CITY OF FRANKLIN PLAN COMMISSION MEETING* FRANKLIN CITY HALL COUNCIL CHAMBERS 9229 W. LOOMIS ROAD, FRANKLIN, WISCONSIN AGENDA THURSDAY, NOVEMBER 3, 2022, 7:00 P.M.

City of Franklin Plan Commission Meeting October 6, 2022 Minutes

REPORT TO THE PLAN COMMISSION

SHEET 1 OF

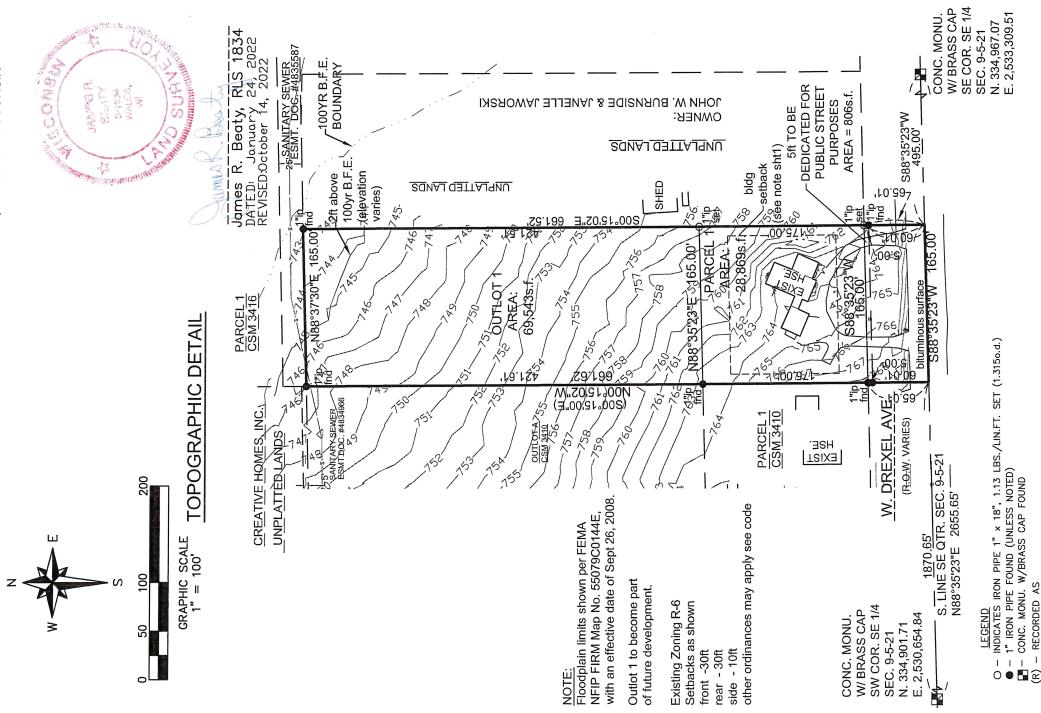
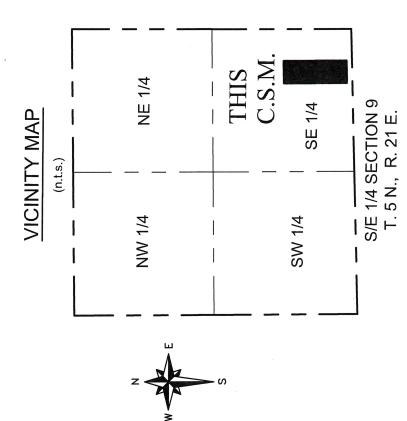
- No objection to this proposal. However, technical issues and conditions/comments from Engineering and Milwaukee County must be resolved before recommending its approval.
- On page **1** of 5, under the legend, remove structures to be razed.
- On page 3 of 5, on the second paragraph of the surveyor's certificate insert, "and the City of Franklin Unified Development Ordinance Division- 15 in surveying....".
- On page 5 of 5, replace the Common Council Approval Certificate with:

/ •	"Approved and dedication accepted by the Common Council of the City of
	Franklin by Resolution No. Signed this day of ,
,	20 "
•	Correct the Mayor's name to Stephen
/ •	Remove the Certificate of County Treasurer, City Treasurer, and the City Clerk
Milwa	aukee County

Comment: All preliminary reviews require the CSM to be to scale and the correct size.

Comment: Outlot 1 creating a land lock parcel. Will outlot 1 need access to a road? Page 2 is miss ng Parcel 1 on the diagram. The legend information at the bottom of page 1 has strike overs

CERTIFIED SURVEY MAP NO

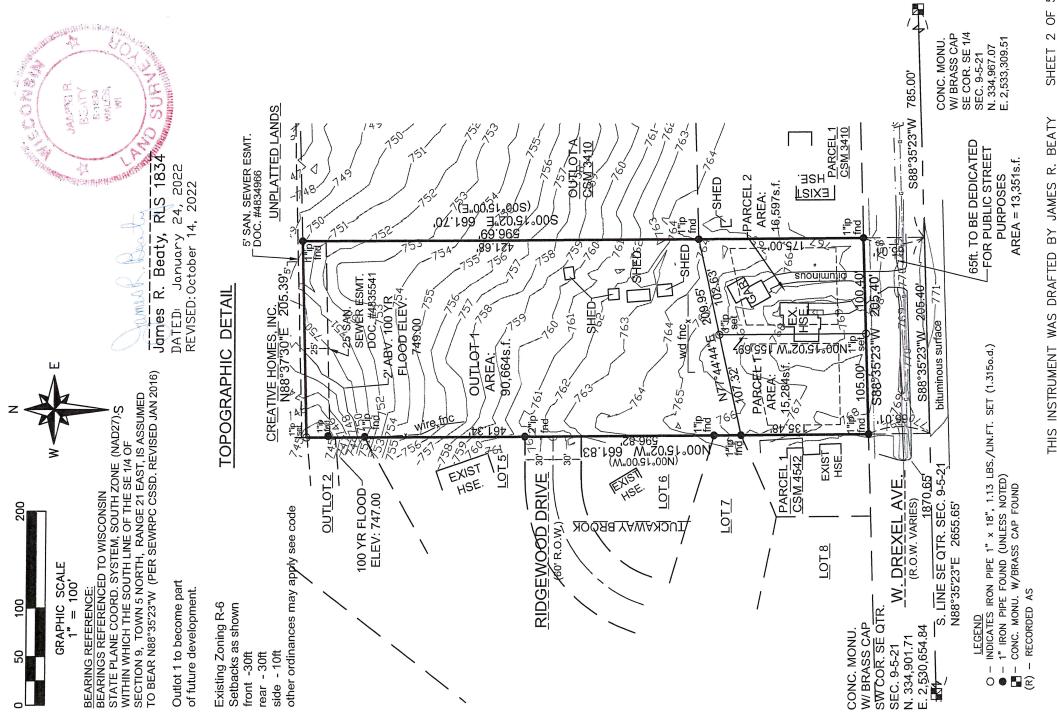
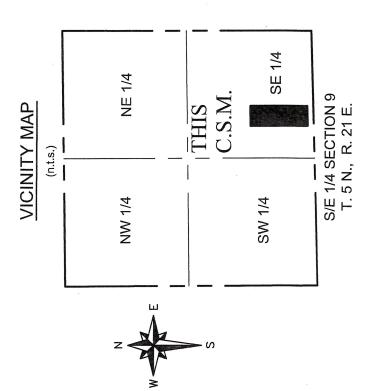
Comment: All preliminary reviews require the CSM to be to scale and the correct size. The current map has overstrikes, and the text is to small or not legible. The scale graphic is not 1-100 as noted.

Comment: Verify all distances and bearings against the legal description on page 3. Verify the N lines of parcel 3. Distances of 205.40 stated in the legal does not match 204.39 on the diagram on page 1. Verify the total acreage of each lot. The current information is not legible.
